Flaxen Dress Maker Ltd-1

14th November 2018

Observations

Floor layout plan

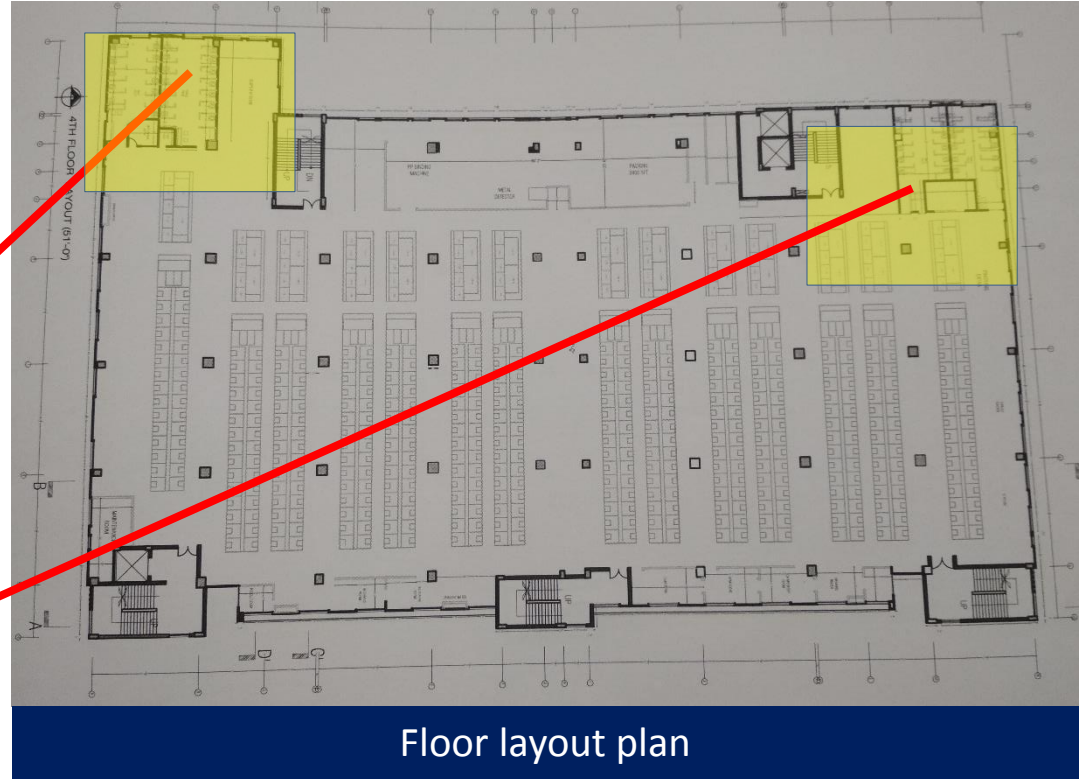
**Column to be stressed above normal
design limits**

Observation : Main Production Building

Cursory calculations indicate that few Columns under toilet area would appear to be stressed in excess of normal design limits, assuming minimum concrete strength. Building Engineer to review design, loads and columns stresses. Also, prepared load plan need to be revised based on floor, column and foundation capacity.
